PRECISE GRADING PLAN FOR RIVERVIEW SPRINGS

SHEET 1	CITY OF OCEANSIDE ENGINEERING DIVISION	23 SHEETS
PRECISE GRADING PLAN FOR RIVERVIEW SPRINGS		
ACCEPTED BY:		
CITY ENGINEER: BRIAN K. THOMAS R.C.E. 60907		Date: _____
PLANS PREPARED UNDER THE DIRECTION OF	REVIEWED BY:	PLAN NUMBER
Sign: Name: BRENT C. MOORE Date		G22-00031

PRIVATE SEWER PLAN FOR

RIVERVIEW SPRINGS

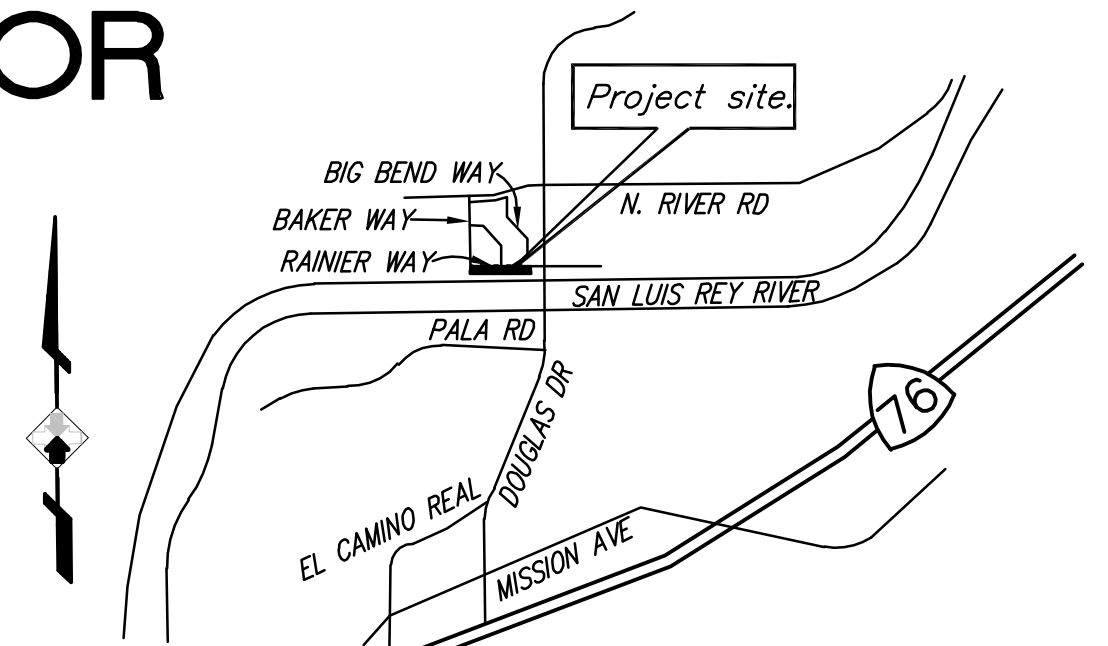
ADD SIGNATURE BLOCK FOR WATER UTILITIES DEPARTMENT
